SUBJECT: COMANCHE PEAK STEAM ELECTRIC STATION (CPSES)
DOCKET NOS. 50-445 AND 50-446
SWING ARMS FOR BORG WARNER CHECK VALVES
10CFR21 REPORT P21R-92-001

10CFR21 REPORTABLE CONDITION INVOLVING
SWING ARMS
FOR BORG WARNER CHECK VALVES

(ii) The facility is Comanche Peak Steam Electric Station Units 1 and 2. The basic components are swing arms on Borg Warner check valves model number 75510 which are not completely interchangeable with the original parts.

BORG-WARNER CHECK VALVE INTERNALS

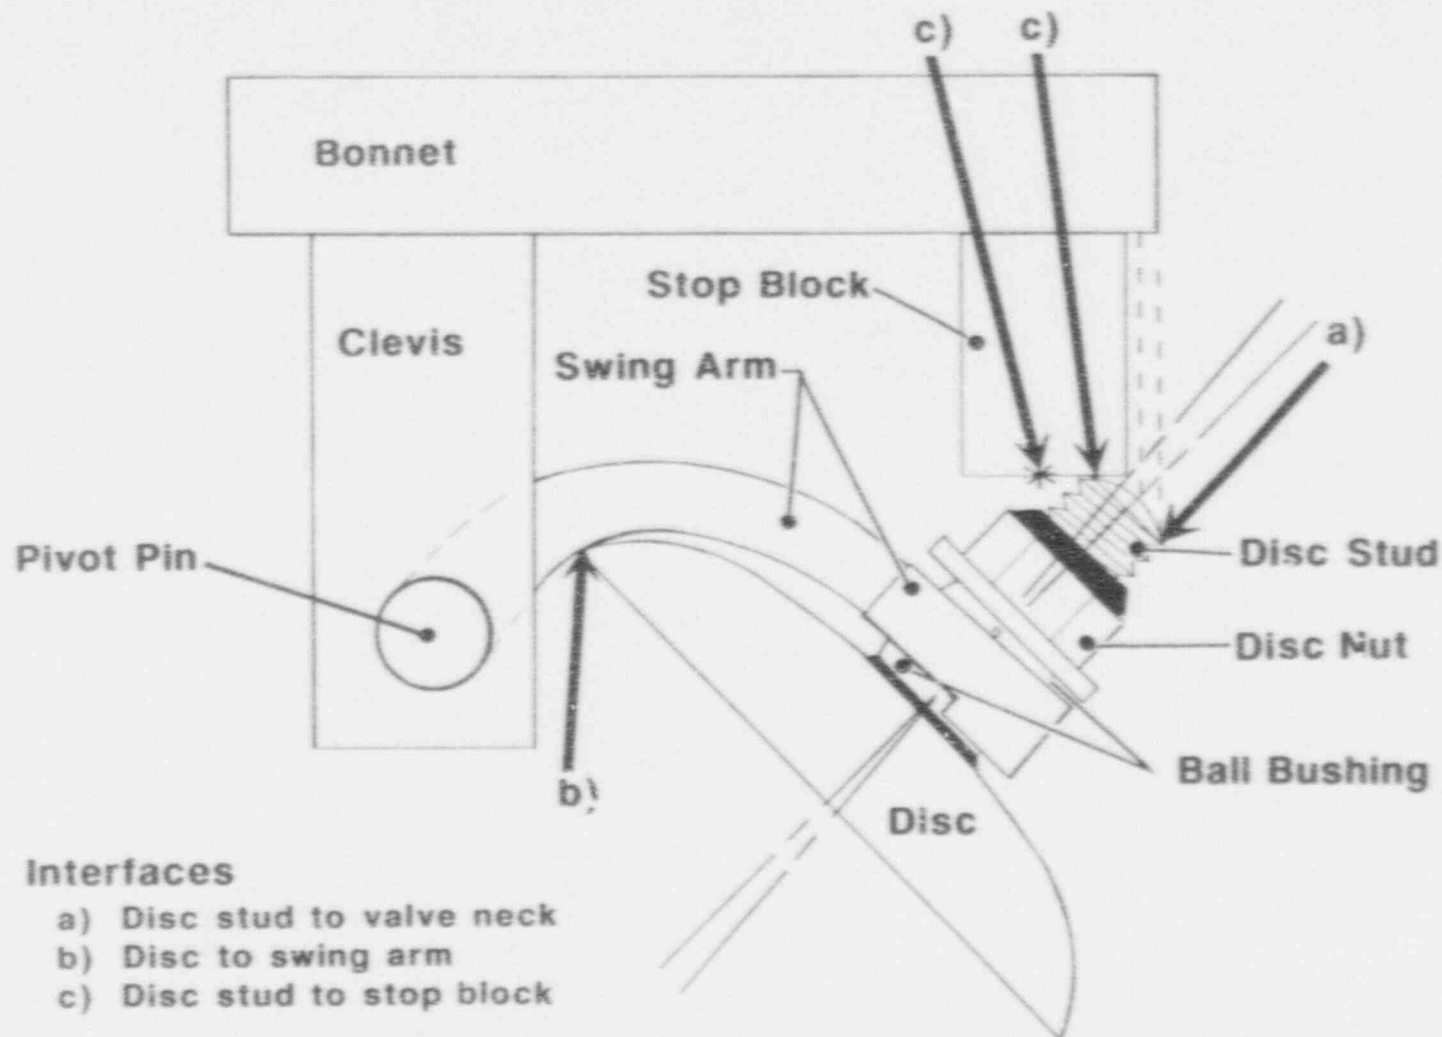
The swing arm is a machined steel casting attached via clevis and pivot pin to the valve bonnet (see sketch on Page 4). The bonnet provides a mounting point for the clevis. The valve disc is attached to the swing arm via a disc stud and a disc nut. A ball bushing is located at the point where the disc stud passes through the swing arm. The check valve is in the open or closed position depending on direction of flow through the valve body. When fully open, the arc of the swing arm and disc assembly is limited by contact between the disc stud and a stop block mounted on the valve bonnet. The disc is maintained in the open position when flow is in the required direction. The disc is activated to the closed position when flow is in the other than the required direction. The swing arm is part number 72543 on BW/IP valve model number 75510. This valve is a 3" - 900# swing check valve.

An engineering evaluation prior to reinstallation of the reworked bonnet assembly with the new swing arm revealed several concerns regarding the operability of the check valve with the new swing arm installed. When the new swing arm is in the up position:

- a) An increase in the maximum arc length of the disc stud increases the possibility of contact with the valve neck which could possibly contribute to valve hang-up or valve damage.
- b) The disc may impact the swing arm which could lead to valve damage, and
- c) The disc stud makes contact closer to the far edge of the stop block resulting in a possible hang-up location.

TU Electric had previously performed the following modifications to the valves which may have contributed to the observed problems:

- a) A modification was made in 1983 to replace tack welds which hold the disc stud to the disc with a full fillet weld. This modification was made because of the potential for valve internals to come apart during operation, and as a result of a recommendation by BW/IP Inc.
- b) The ball bushings were modified, as specified by BW/IP Inc., to compensate for the fillet weld size and/or the axial clearance.
- c) The 3/8 inch by 5/8 inch stepped disc stud was replaced, in Unit 1 only, with a 5/8 inch stud.

Based on the above, TU Electric has concluded that the replacement swing arms supplied and certified as like for like items, i.e., fit, form and function, are not interchangeable with the original swing arms in the valves modified by TU Electric. Use of the revised part as interchangeable with the original could provide a potential for failure of the valve to close, e.g., lodging open when the disc assembly is forced into an adverse configuration. Backleakage through the valve could lead to degradation or inoperability of associated safety related equipment or systems. This condition is considered a defect.

- (v) Information of the defect was obtained from the TU Electric evaluation which concluded on January 14, 1992, that the deficiency was a defect.
- (vi) As discussed in (vi) above TU Electric has a total of six (6) 3" - 900# class pressure seal bonnet BW/IP check valves.
- (vii) TU Electric reinstalled the old swing arm. A successful backflow test was performed on the subject valve. TU Electric is evaluating the need to modify the valve to facilitate use of the replacement arms supplied by BW/IP Inc. in order to assure acceptable operation.
- (viii) Not applicable.
